## ADDENDUM #6

DCA Project No.: 22-136  
Project Name: York Region Warehouse Upgrades

**Addendum #:** E01

SCALE AS SHOWN DRAWING No. M301

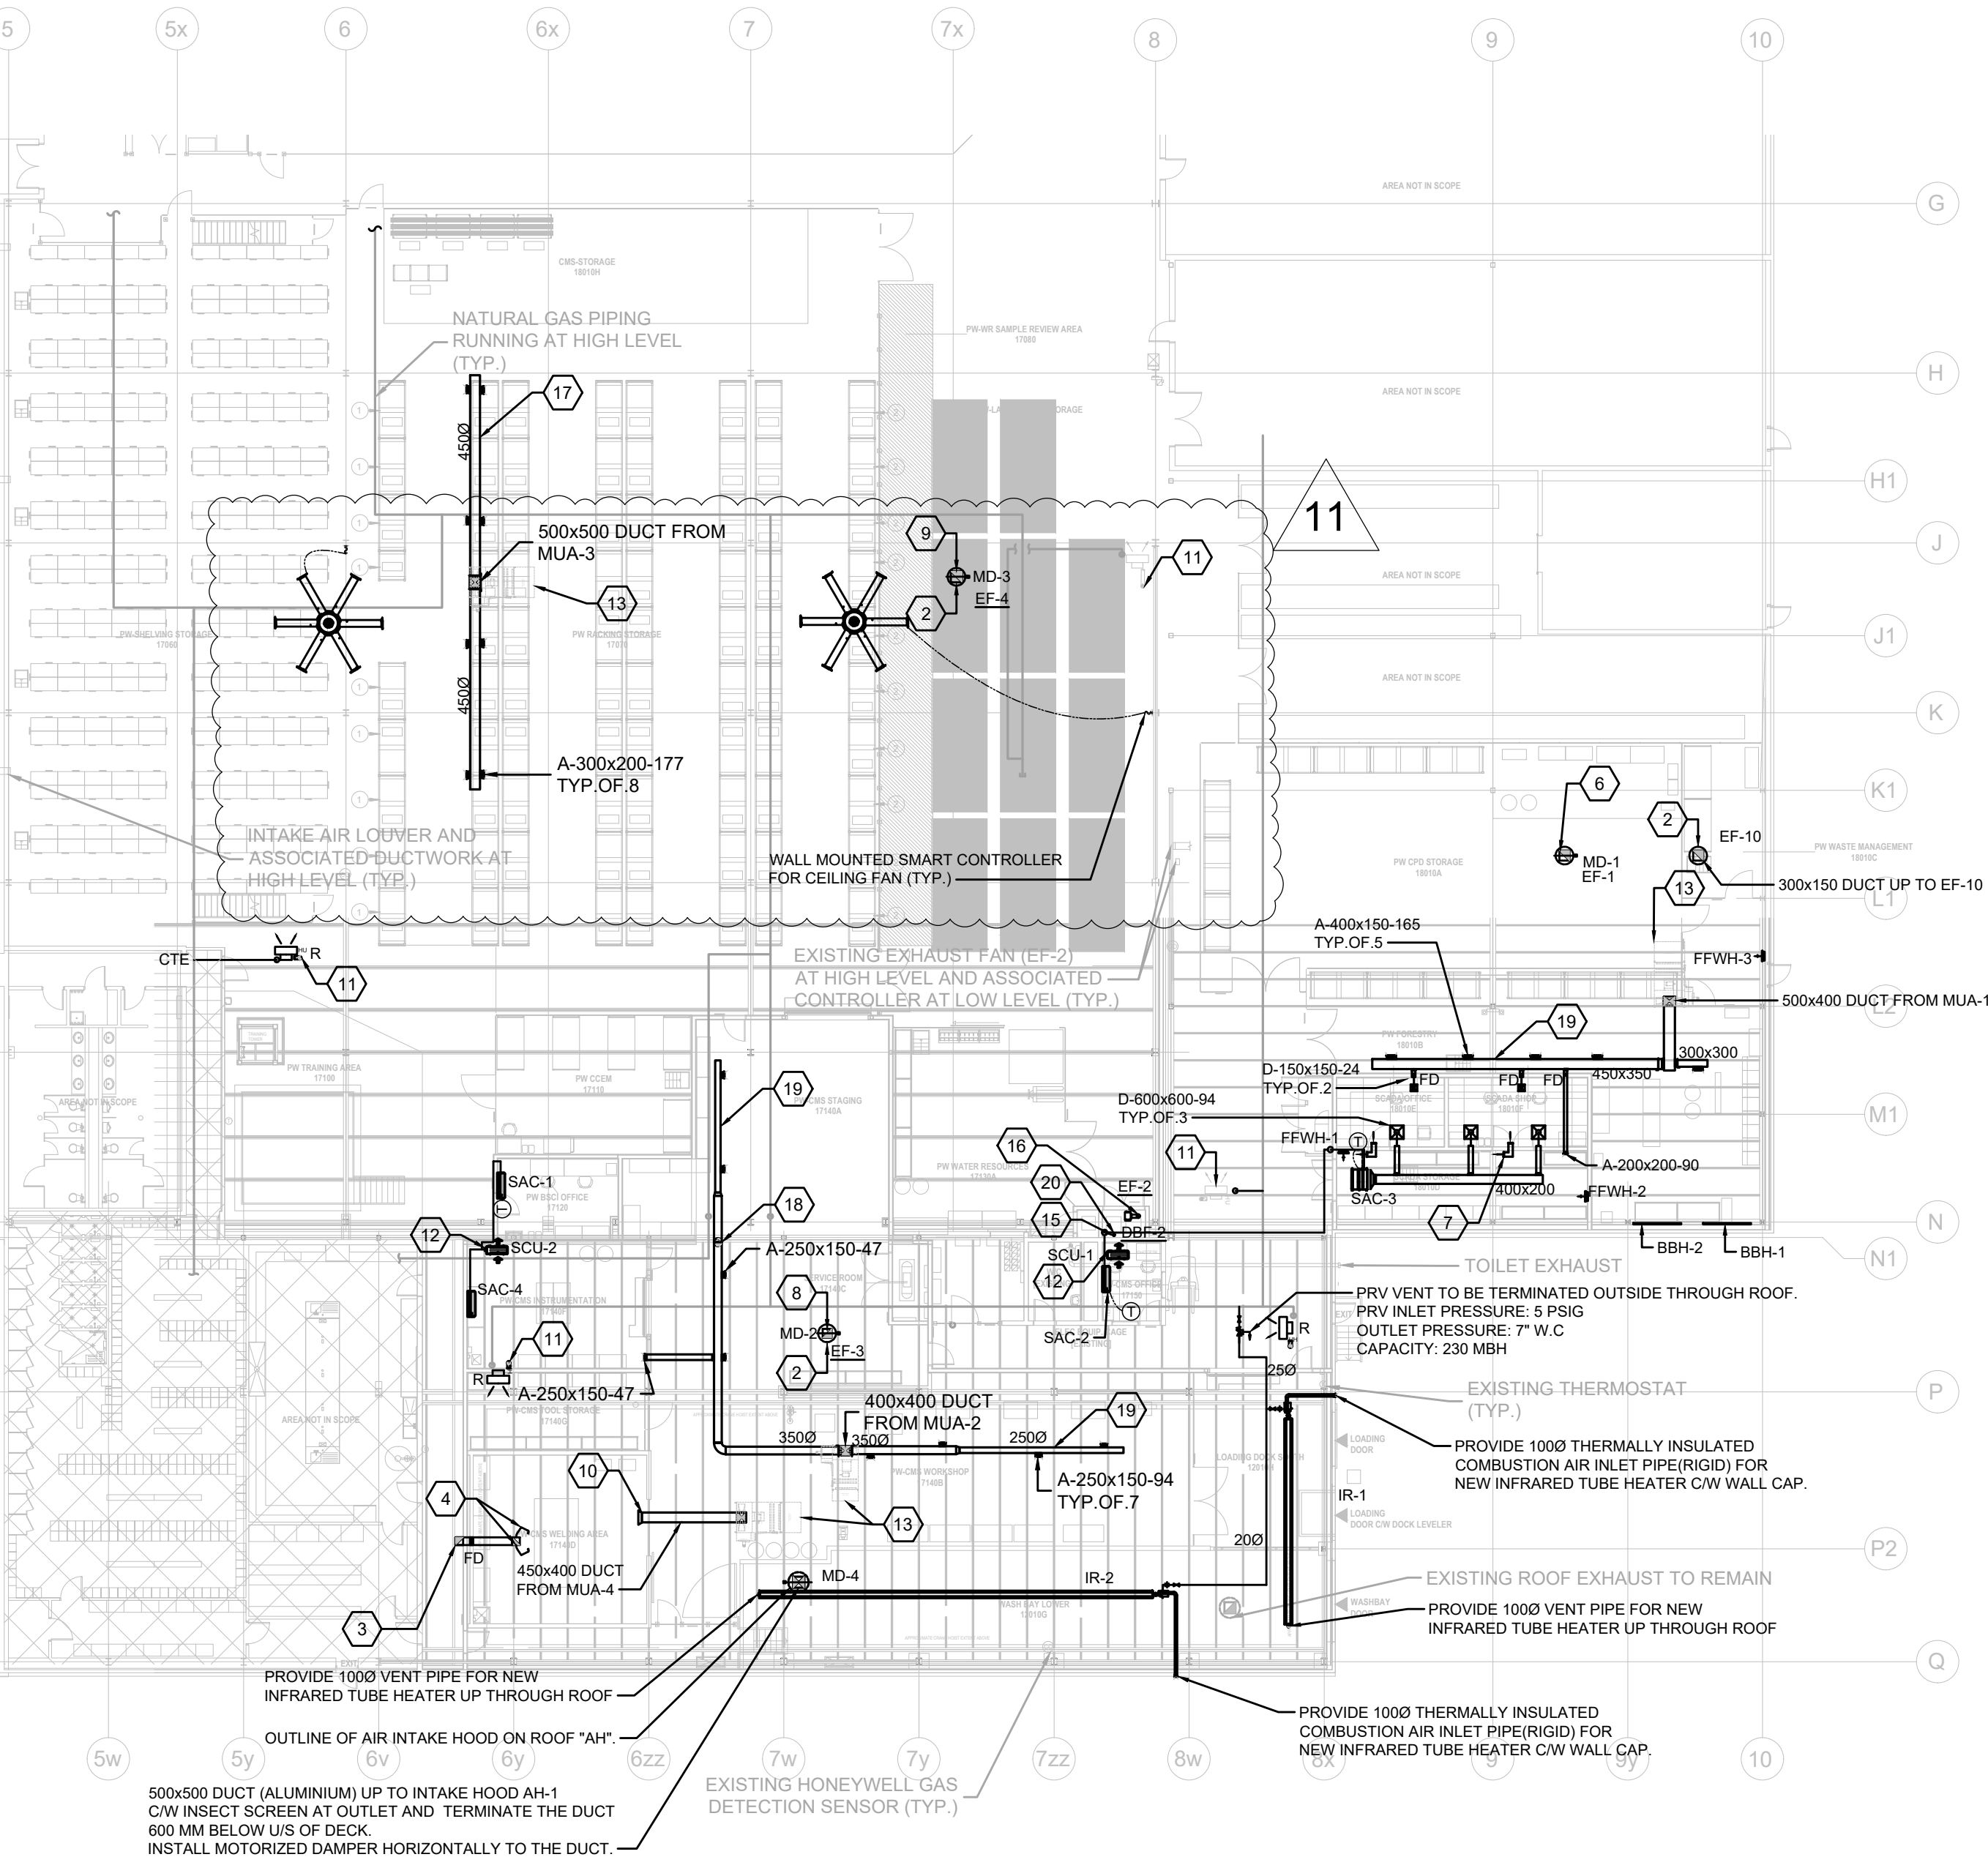
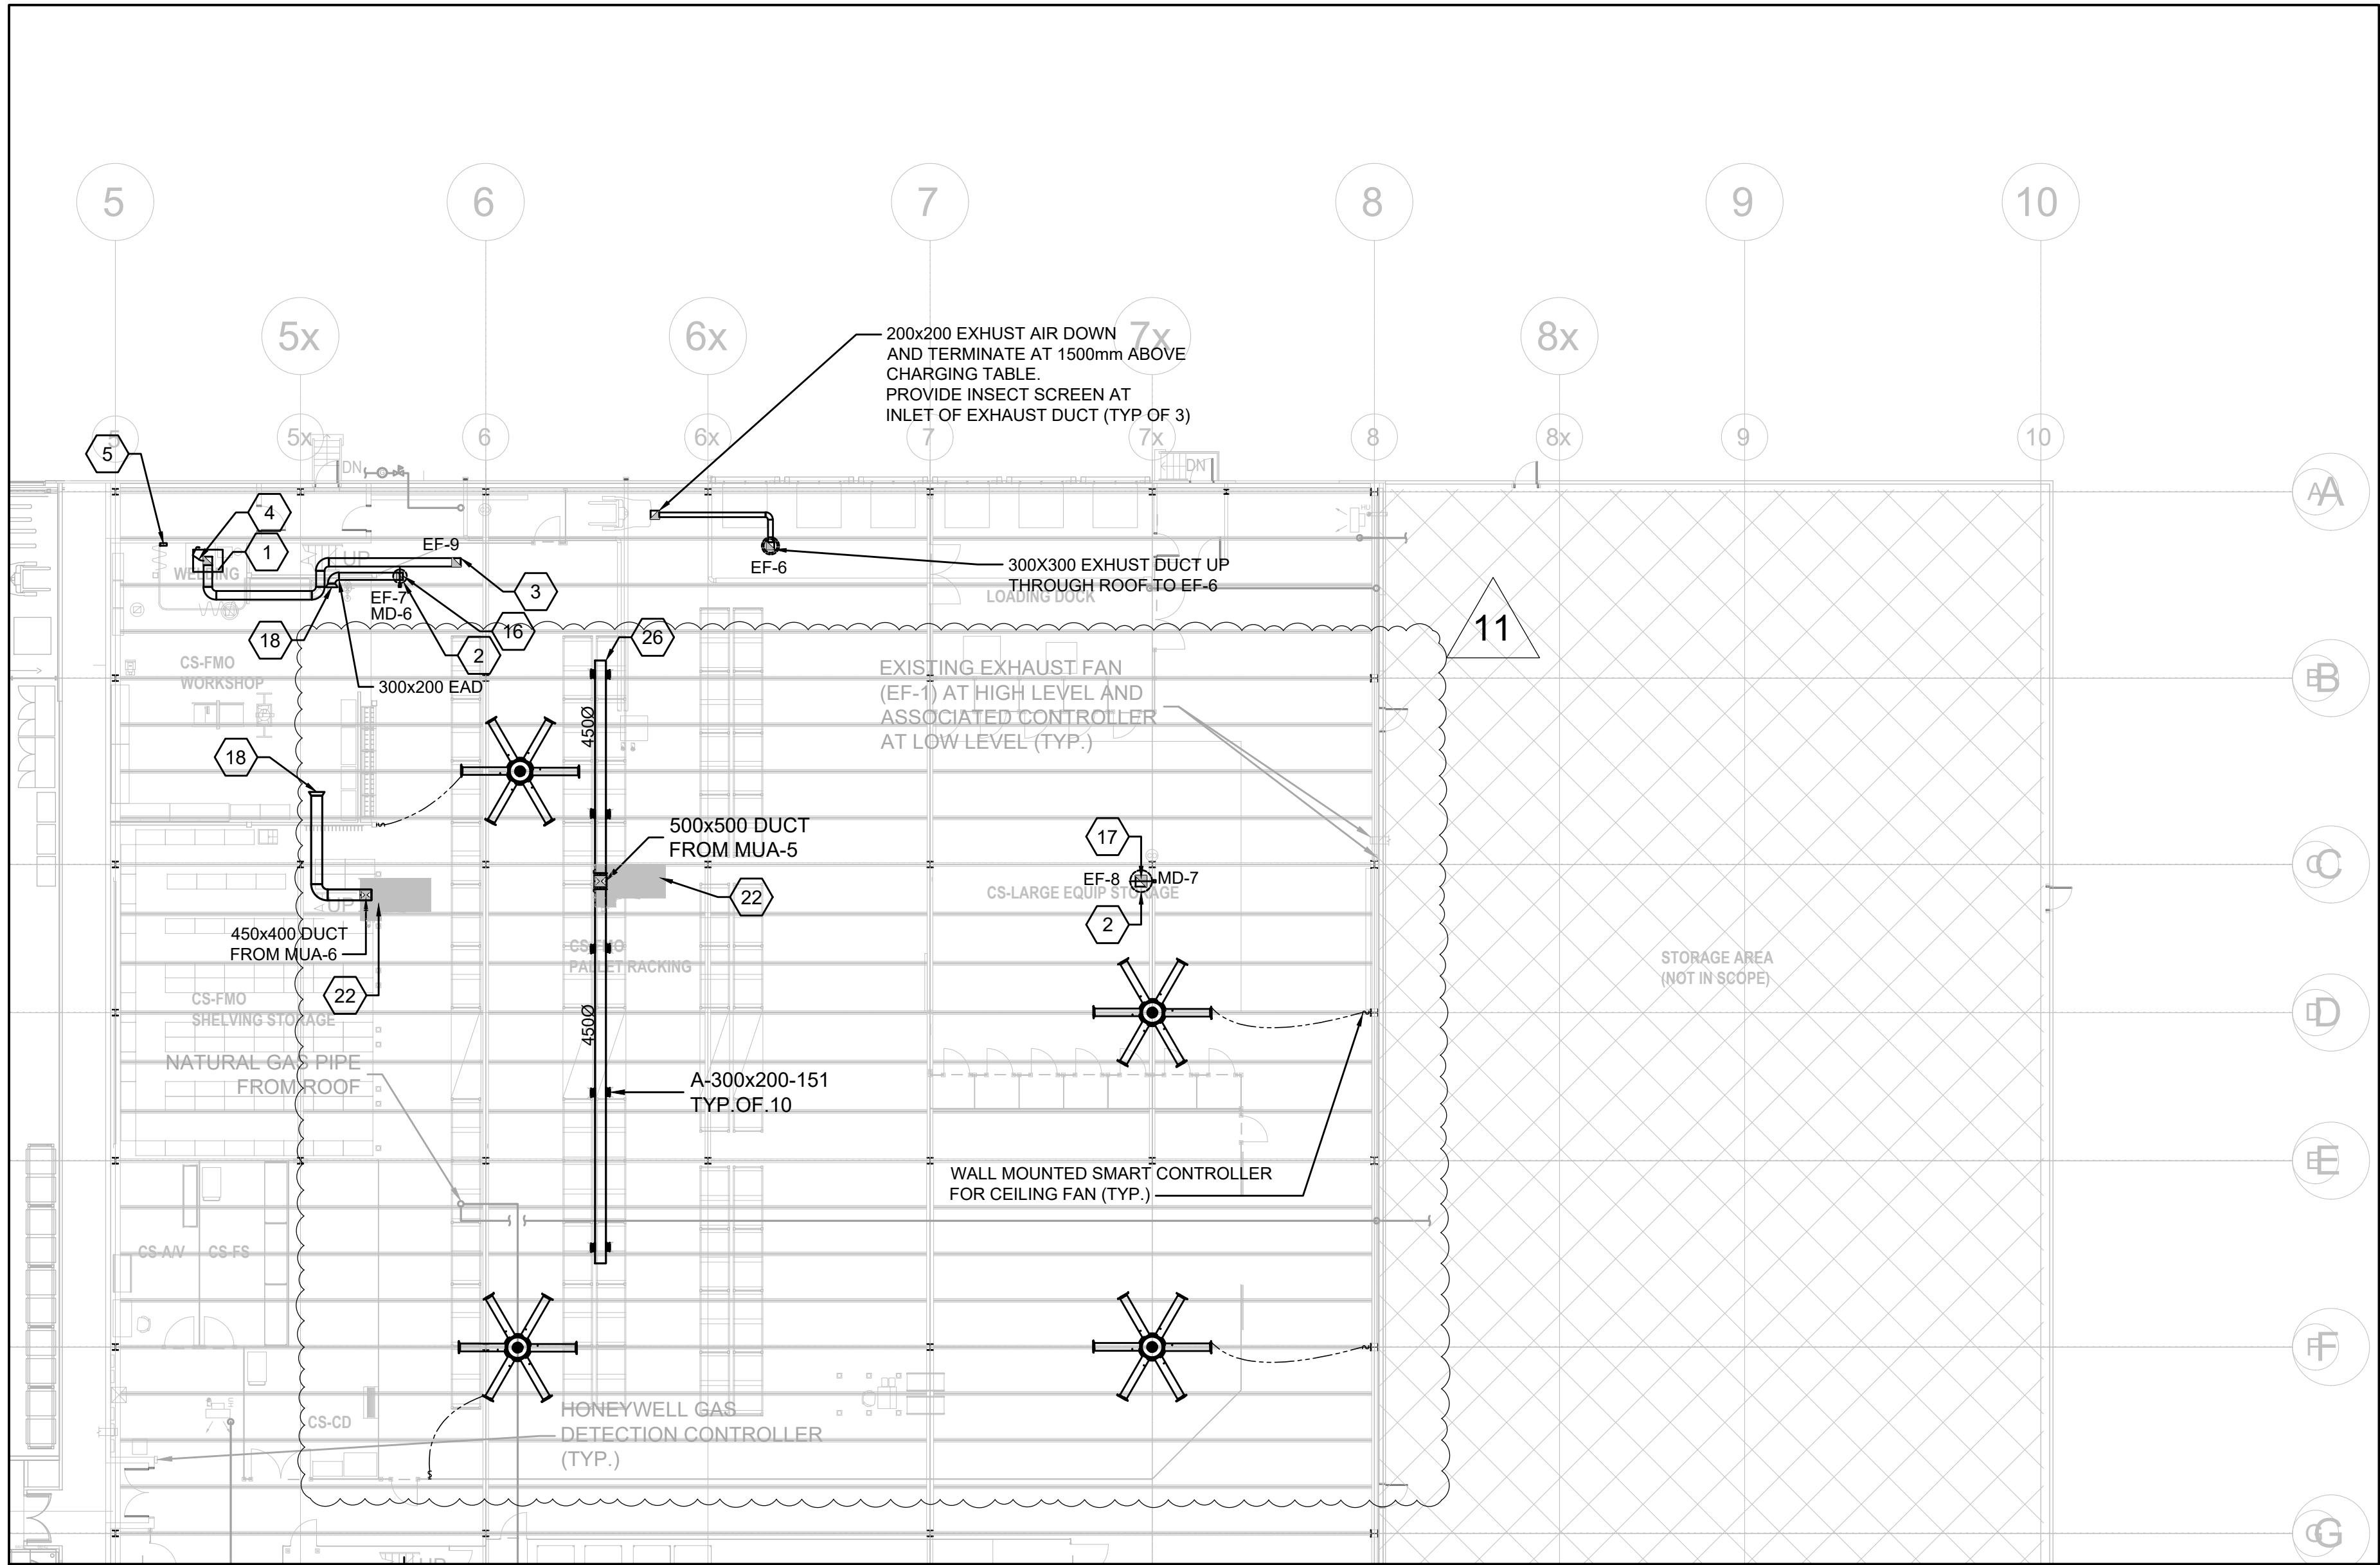
**2. Drawing M301. - HVAC New Layout**

- a. Additional demo notes and drawing added to show the removal of the existing ceiling fans and the existing split AC system in the office space.
  - i. General Demo Note 1: All existing ceiling fans to be removed along with all associated control wiring.
- b. Ceiling fans added to warehouse space.

- ALL EXISTING CEILING FANS TO BE REMOVED ALONG WITH ALL ASSOCIATED CONTROL WIRING.

EXISTING SPLIT AIRCONDITIONING UNITS AND ASSOCIATED CONDENSERS TO BE DEMOLISHED

4 SPLIT AC SCHEMATIC  
SCALE:

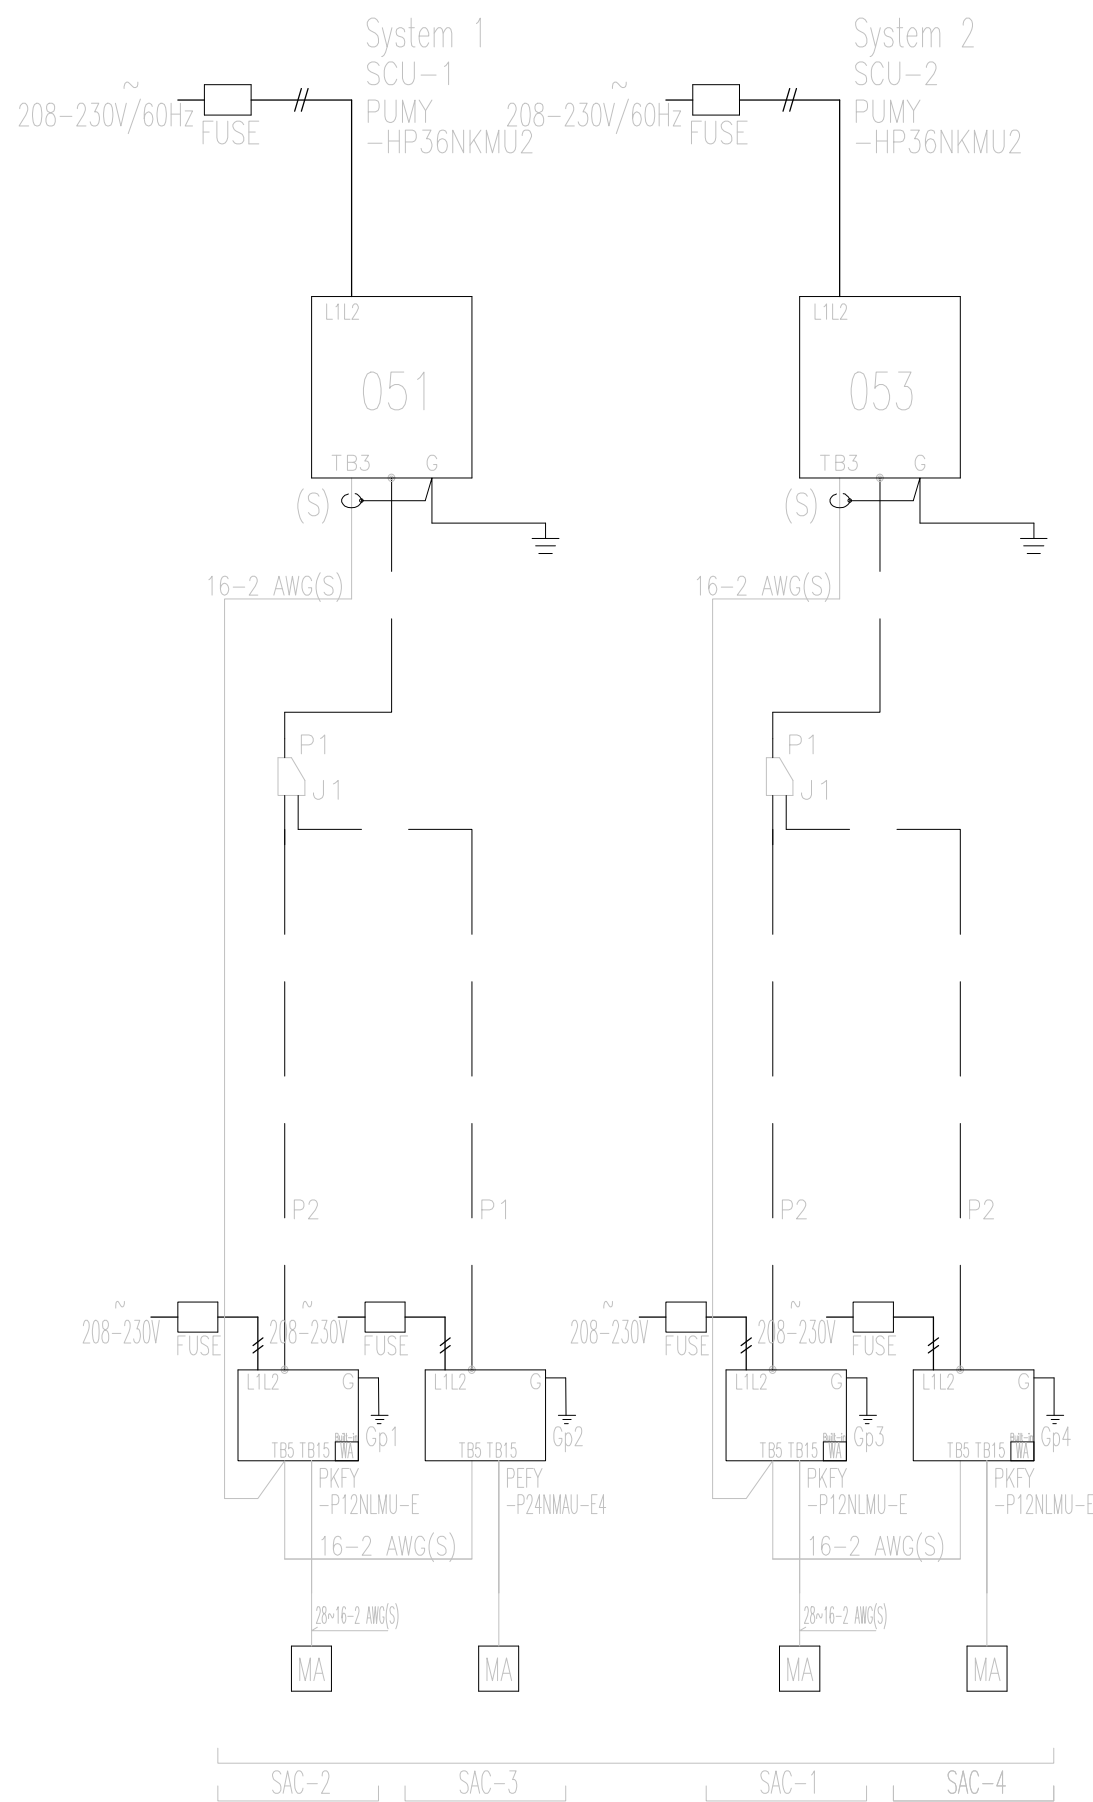
**5. Drawing M504. – Mechanical Details**

- a. Split AC schematic added.
  - i. Detail 4: Split AC Schematic
